**NOTICE OF ADDENDUM
 ADDENDUM NO. 1**

**CONTRACT NO. 8301
 Reetz Road and Altem Circle Resurfacing Assessment District - 2019**

REV 2/26/2019 DAO

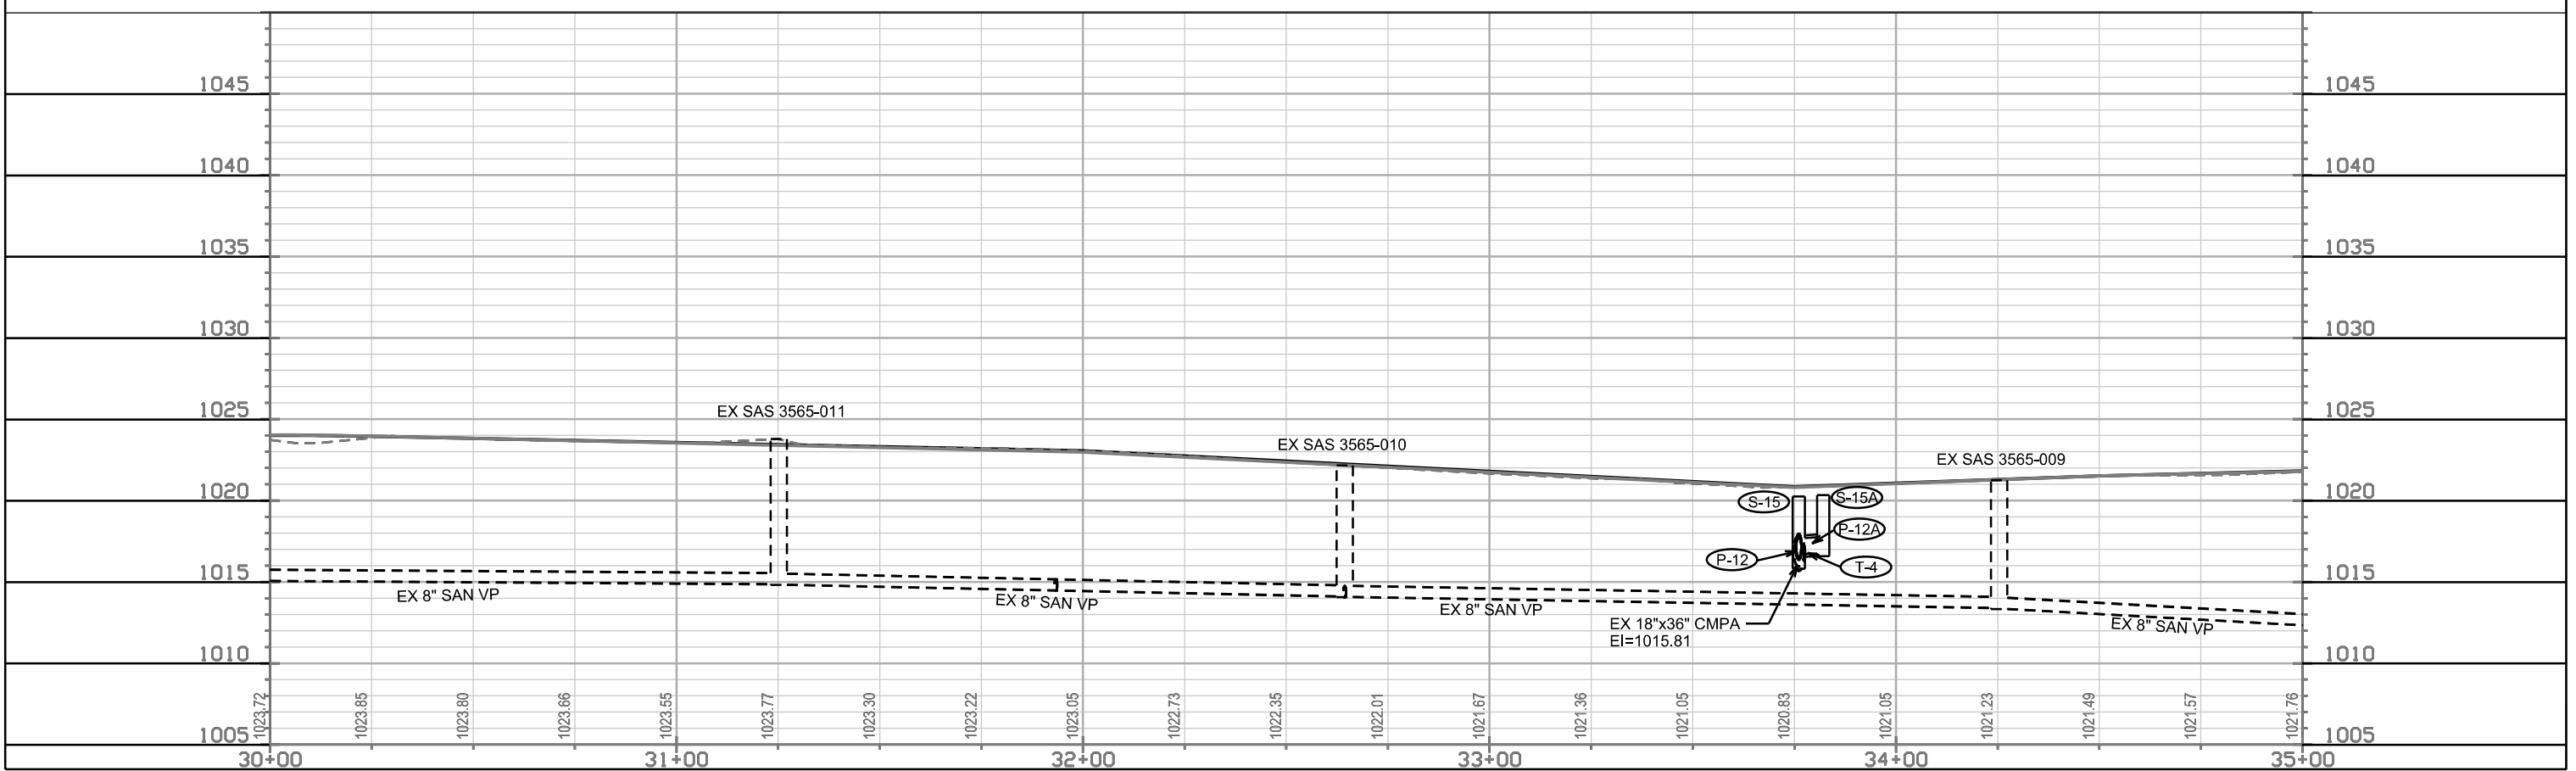
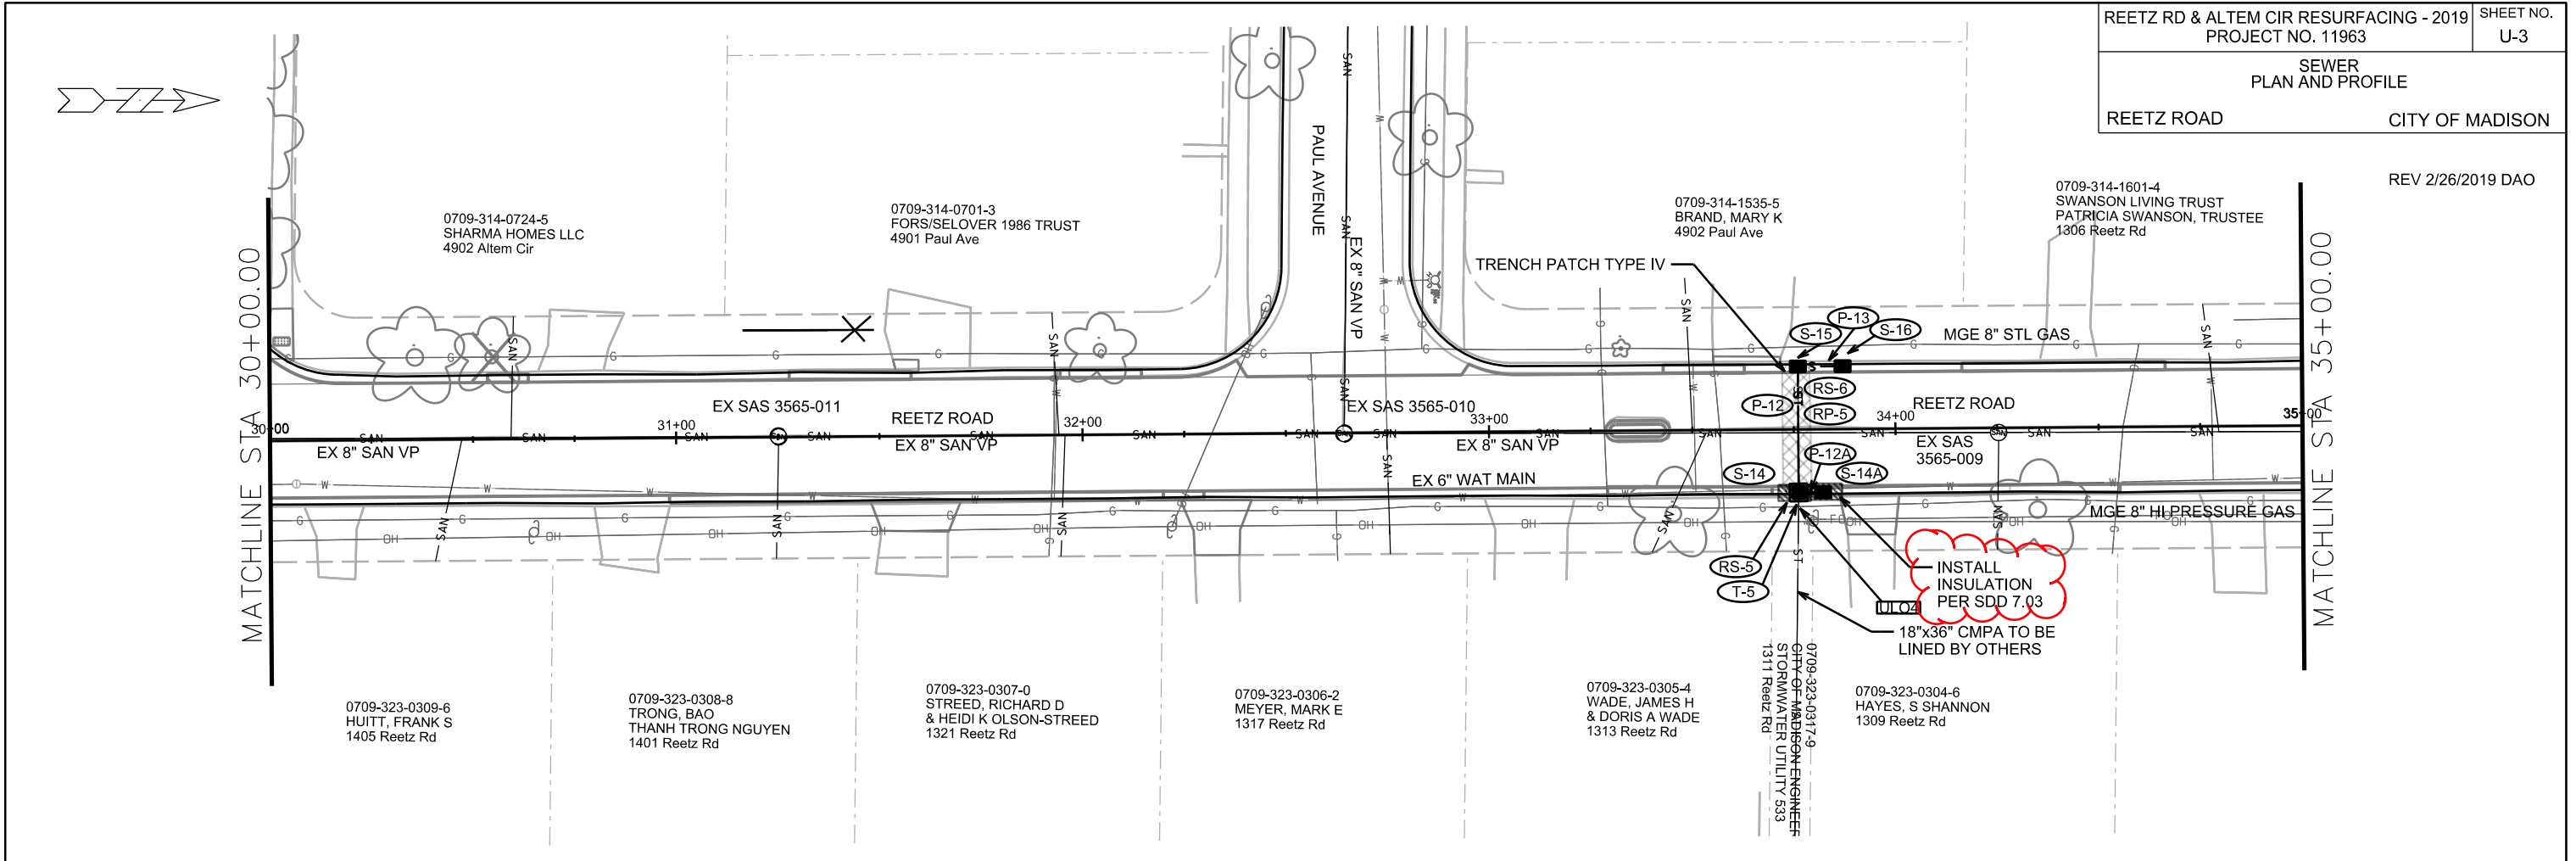
Added insulation between storm pipes and storm structures at the existing water main. Pipe inverts adjusted to avoid conflicts with water main.
